Representation regarding planning permission appeal

Site to the North East of Wee Minnemoer, Millport, Isle of Cumbrae, North Ayrshire KA28 0HF. Case Reference: PPA-310-2039

Cumbrae Community Council

Representation regarding planning permission appeal DPEA ref: PPA-310-2039, North Ayrshire Council ref: N/23/00114/PP

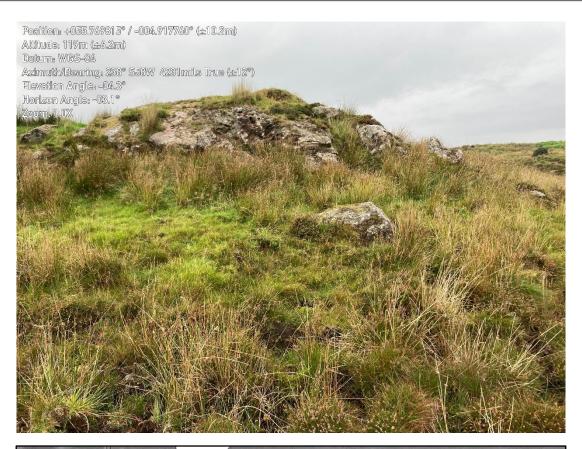
Looking south east from the dam. The design drawings indicate a vehicular track going along the side of a very steep bank with a dramatic change in elevation of 6 to 8m. It would be impossible to construct or use such a track.

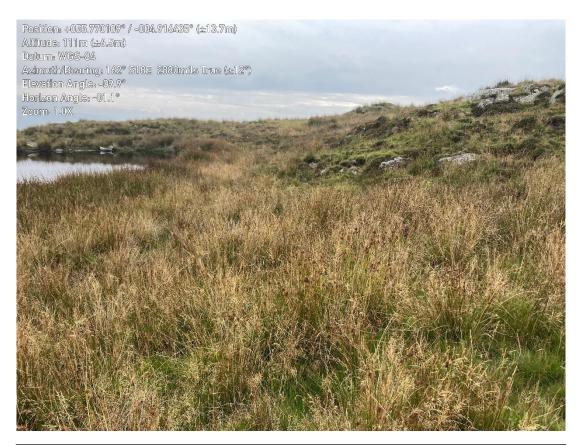
Looking up towards the top of the steep incline above the dam. The design drawings indicate a vehicular track climbing this incline. Such a track would be impossible to construct or to use.
